Subject: Mixed Waste Pond Closure Project
Field Change No. 017

BP CHEMICALS, INC.
MIXED WASTE POND CLOSURE PROJECT

Subject: French Drain for East Side of Cell No. 1

Re: Revised Layout -- French Drain for East Side of V-1 Cell
Mixed Waste Pond Closure Project
BP Chemicals, Inc.
Lima, Ohio

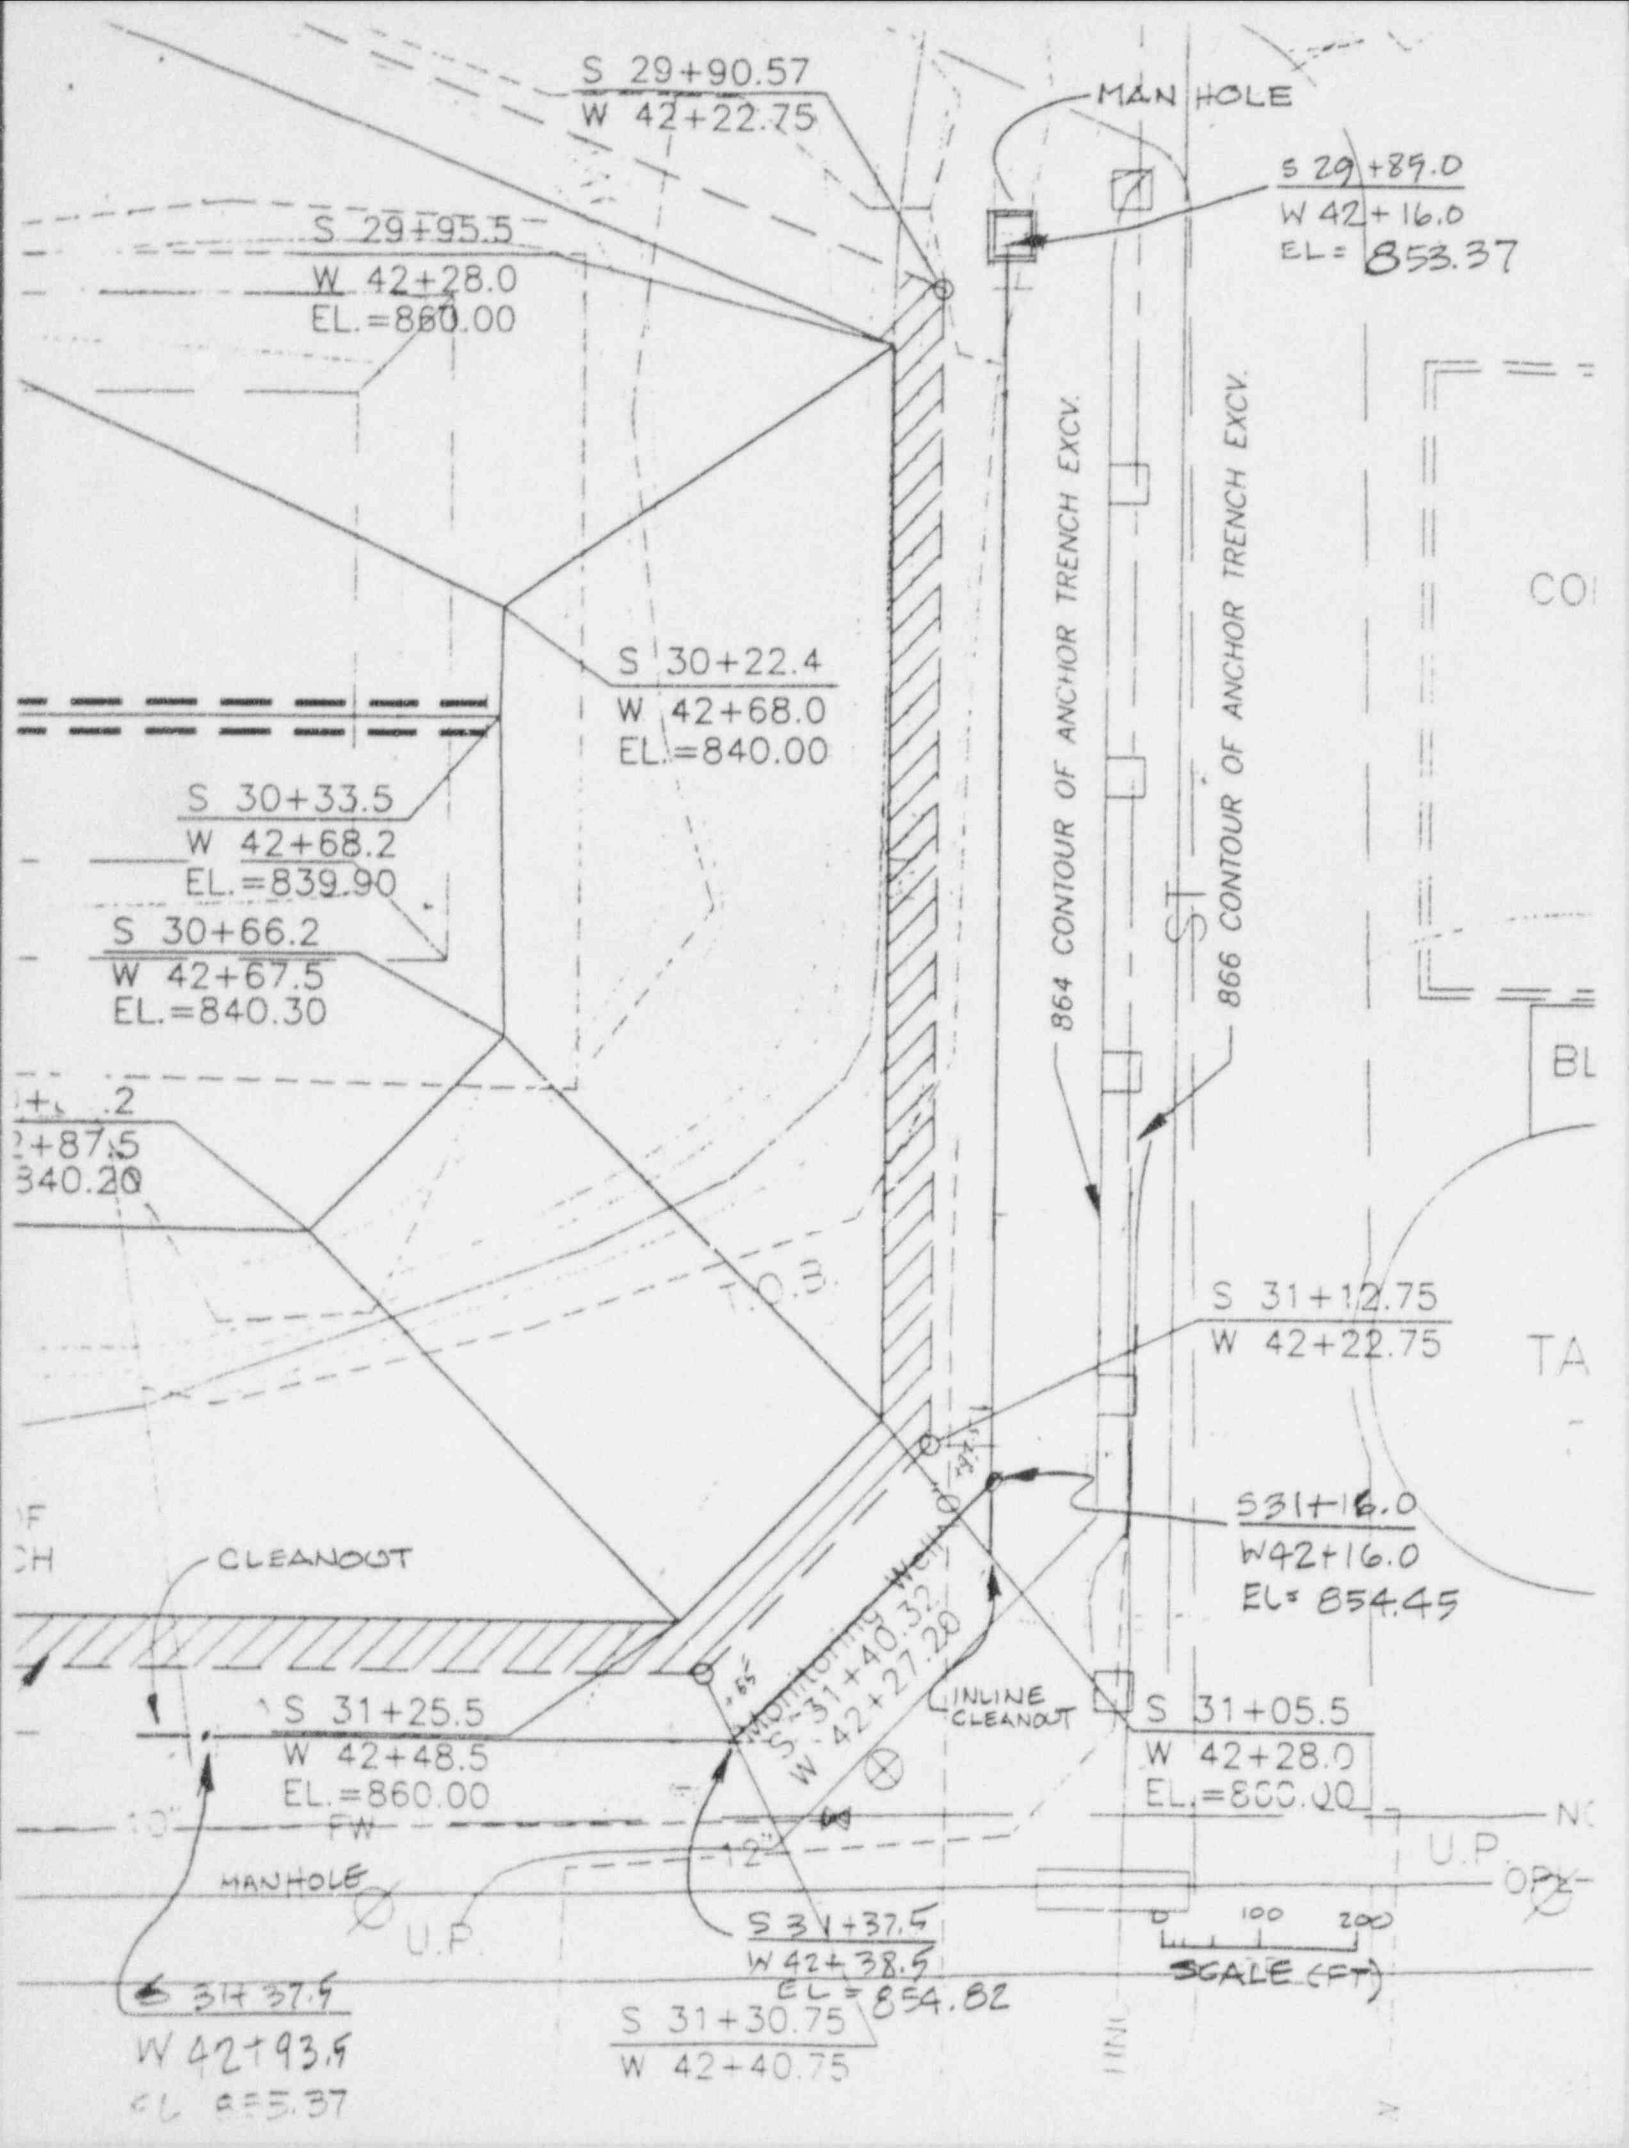
Enclosed please find a revised layout for the French drain proposed for the east side of the cell. As you requested, the drain now flows to the north. During construction, the discharge from the drain will be pumped by the contractor from the manhole at the north end of the drain to a location in the plant NPDES discharge system designated by BP Chemicals. Please replace the layout submitted with the original Field Change Request package (transmitted under our letter of November 15, 1996) with the enclosure.

Attachments: • LAYOUT SKETCH
• TYPICAL CROSS SECTION
• INLINE CLEANOUT DETAIL

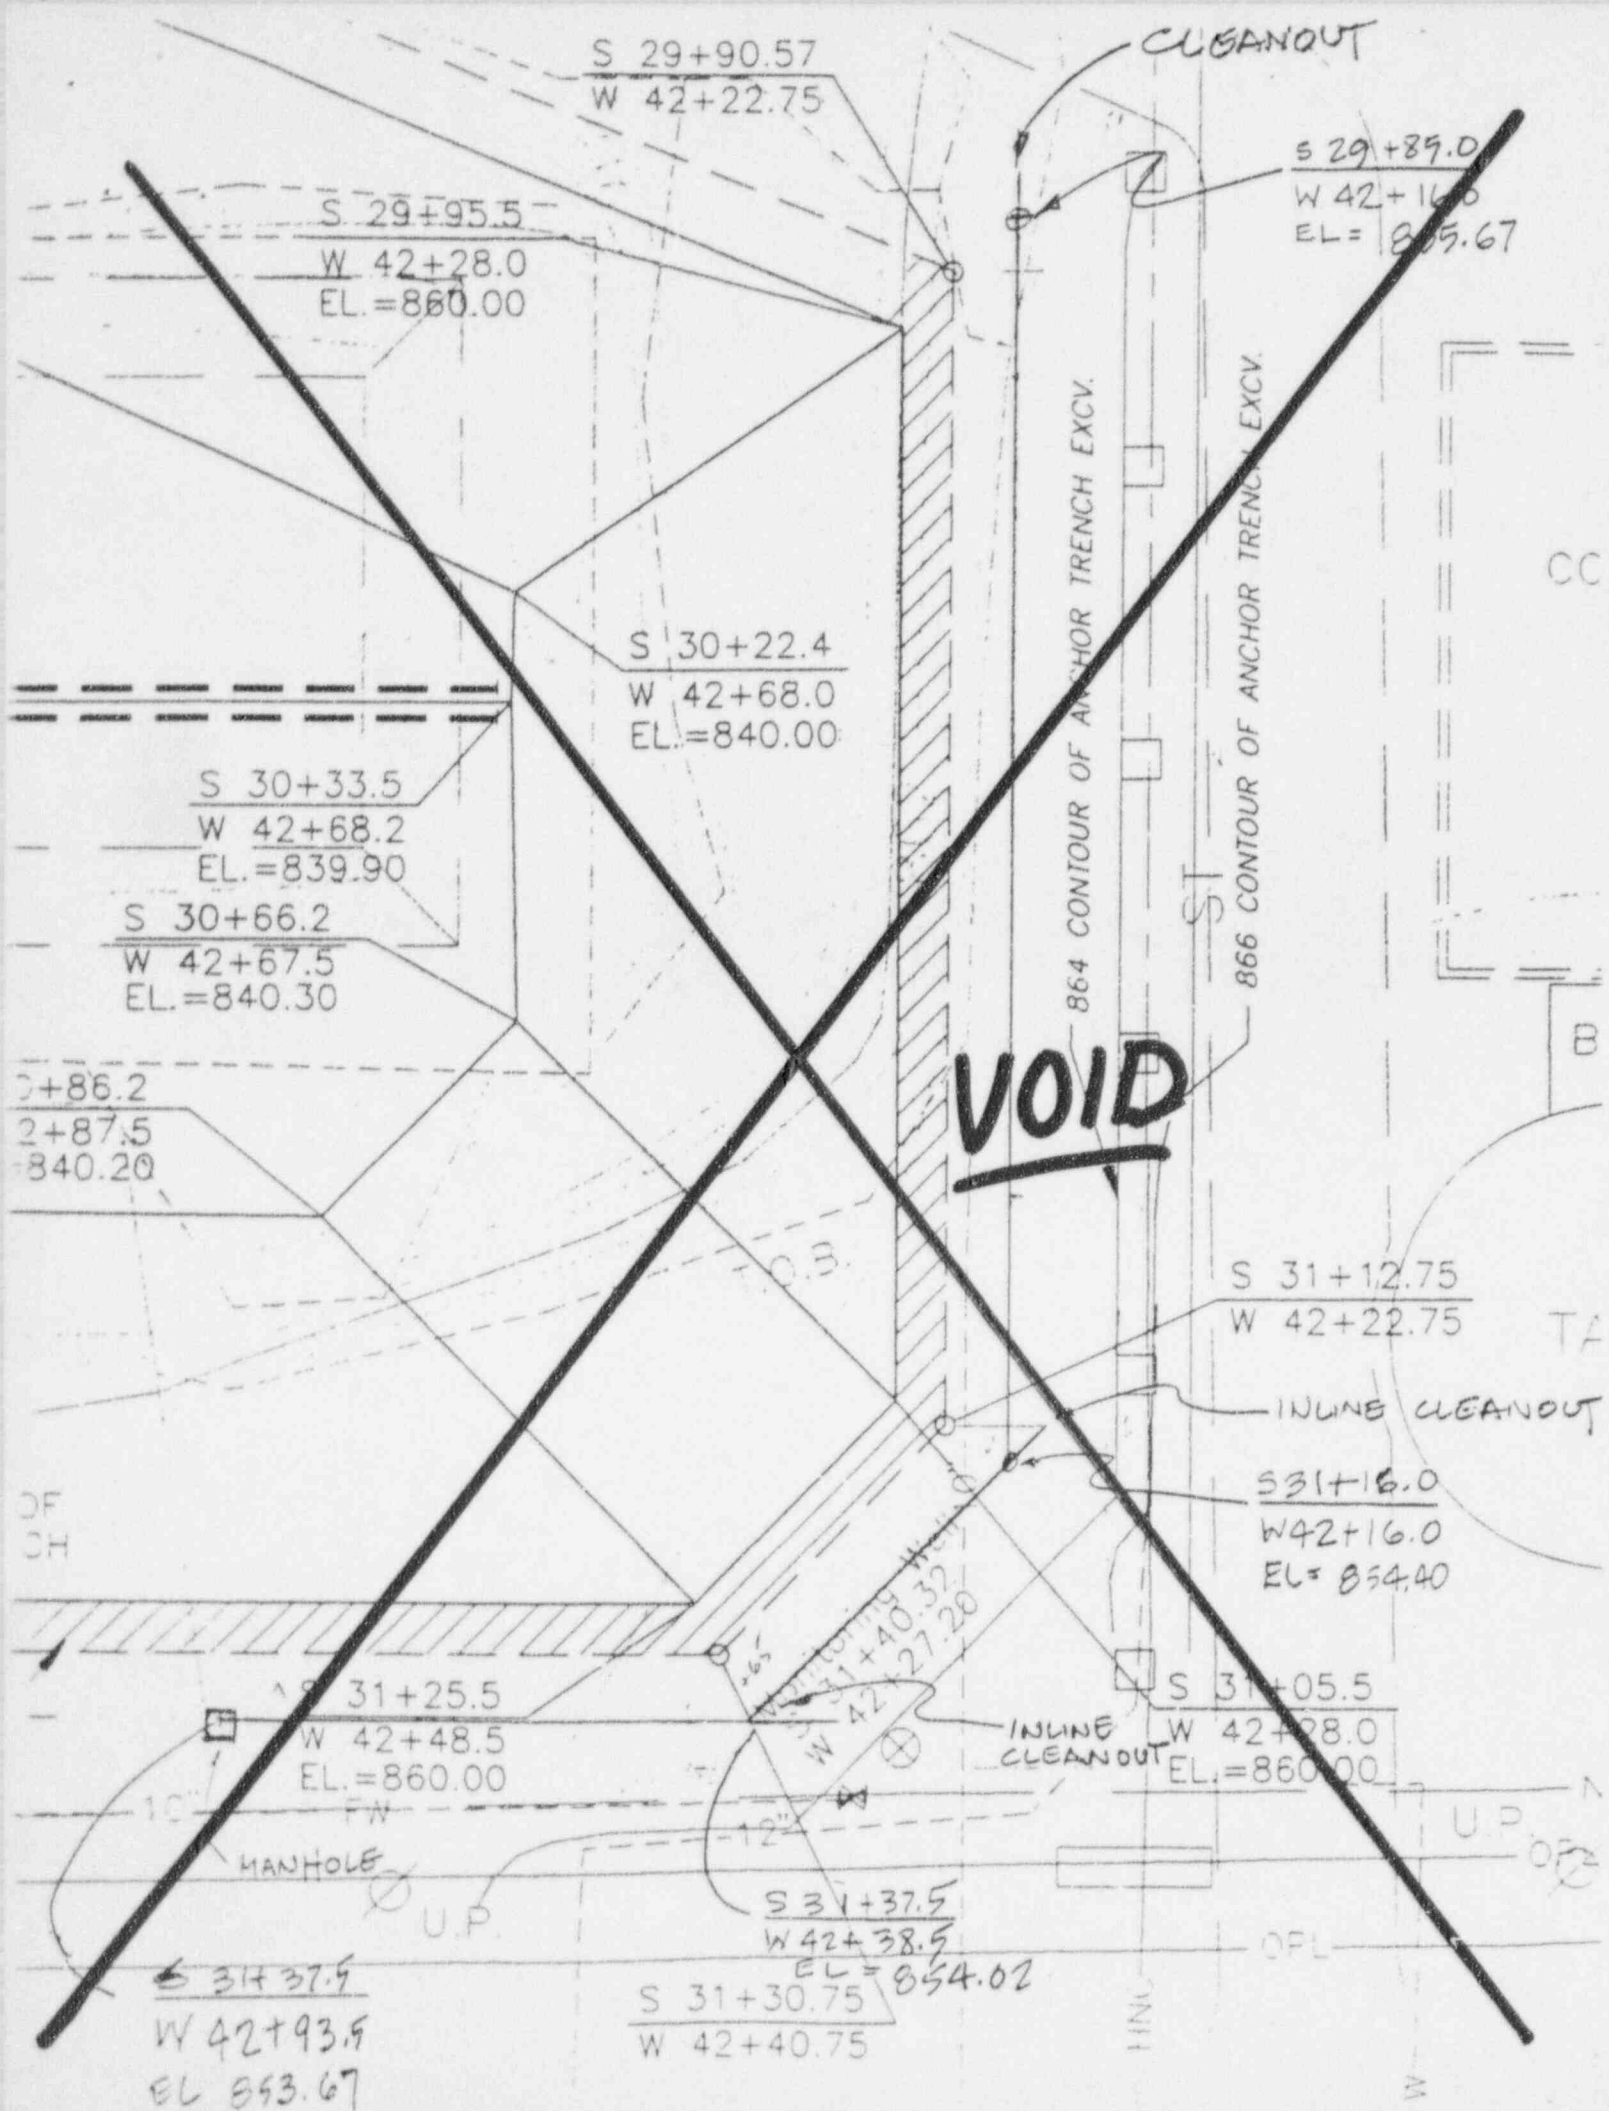
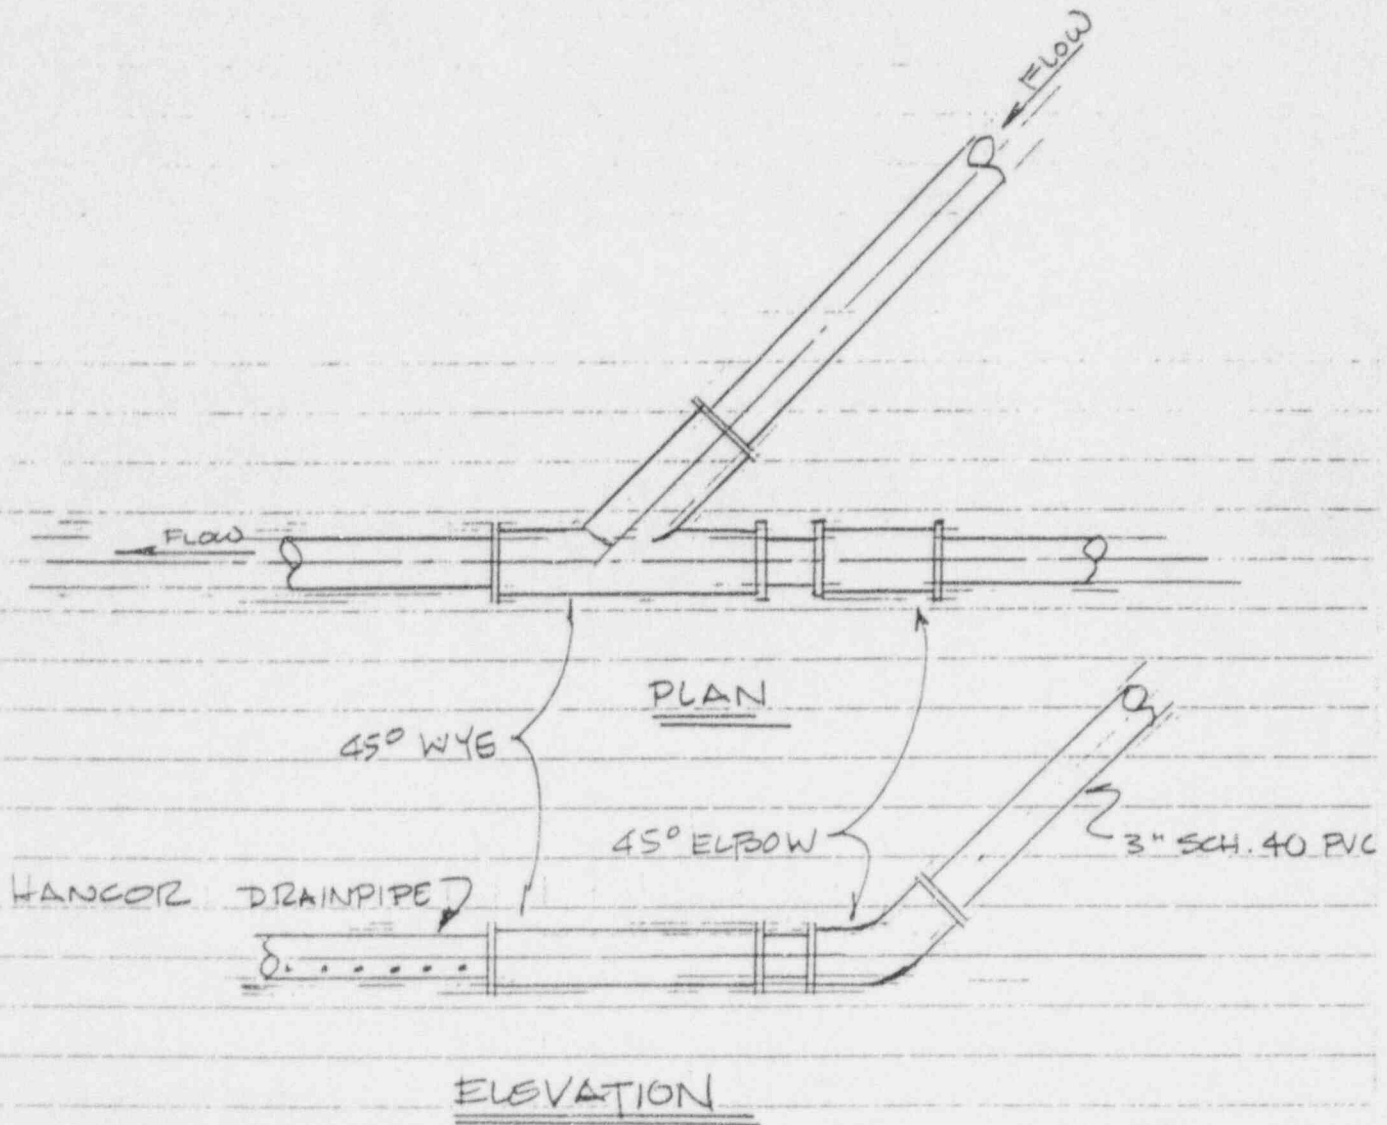
Enclosed please find a field change request and three sketches (plan, cross section and cleanout detail) which describe our recommendations for a french drain to be installed along the east side and at the southeast corner of the V-1 cell anchor trench. Based on information furnished to us, we understand that there is considerable seepage from granular fill material in this area.

1. The distance between the edge of the anchor trench and the drain is reduced to 6.75 ft to accommodate the narrower anchor trench width.
2. The woven geotextile is extended up the back wall of the anchor trench excavation. This conforms to the narrow width anchor trench design covered under calculation BUF-96-110.
3. The manhole should be installed so that the north inside wall is no more than 9 inches north of the french drain pipe. This will prevent excavation encroachment on the geomembrane. Other than this, the manhole design is the same as the one sent to you previously.
4. The layout includes two 45 degree bends. Inline cleanouts should be installed at these locations. A sketch of these cleanouts is provided. The surface finish of the cleanouts is the same as for the french drain on the west side of the cell.

5. A layer of gravel, covered with a non-woven geotextile extends from the backwall of the excavation to the french drain trench. This has been added because of the greater distance between the french drain and the backwall and the increased depth of the drain relative to the design for the west side of the cell.

4'-0" ϕ MANHOLE INST - EAST SIDE FRENCH DRAIN

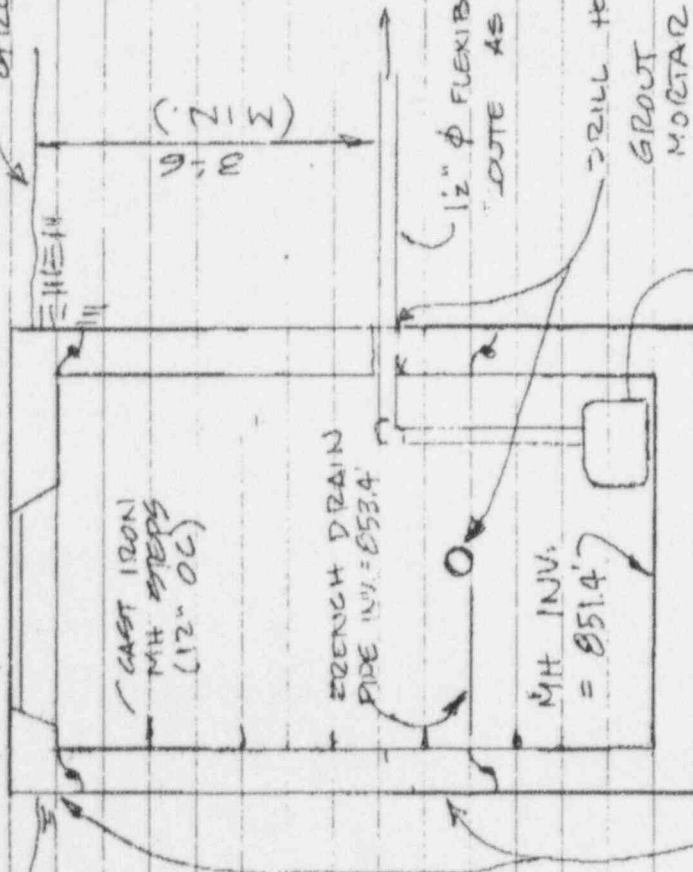
To minimize difficulties with compaction in the tight areas, we recommend using flowable fill for the backfill around the manhole. Also, the manhole excavation should not be initiated until just before the contractor is ready to install it and place backfill. This will minimize the potential for sloughing of the excavation walls.
